PRODUCT CHANGE NOTIFICATION

Product Identification: S553-6500-D6-F, S553-6500-35-F, S553-6500-L2, S553-1445-00-F, S553-6500-A7-F, S553-6500-B9-F, S553-6500-D1-F, S558-5999-AA-F, S558-5999-J5-F, S558-5999-AF-F, S558-5999-Q9-F, S558-5999-Z3-F, S553-6500-F6-F, S558-5999-79-F

PCN Number: PC20160108

TITLE
COMPARISON OF OUTLINE OF PKG WITH/WITHOUT STANDOFF FOR 40 PIN PKG

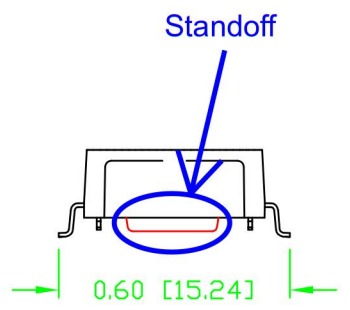
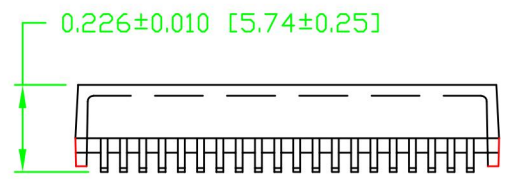
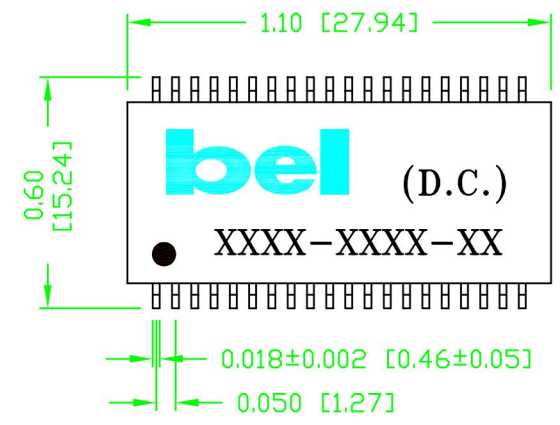
Reason for Change (s): In an effort to continually improve our product, Bel is pleased to announce a change to the mechanical outline drawing of the aforementioned products. We will be adding a standoff to the plastic case, designed to reduce the chance of wire damage. This change will not affect “form, fit, or function”, nor does it affect any electrical parameters or dimensions beyond what is highlighted in the accompanying document. No additional changes are being implemented at this time.

Was

WITHOUT STANDOFF

Is

WITH STANDOFF

Impact on Quality and Reliability: Less chance of damage to magnet wire.
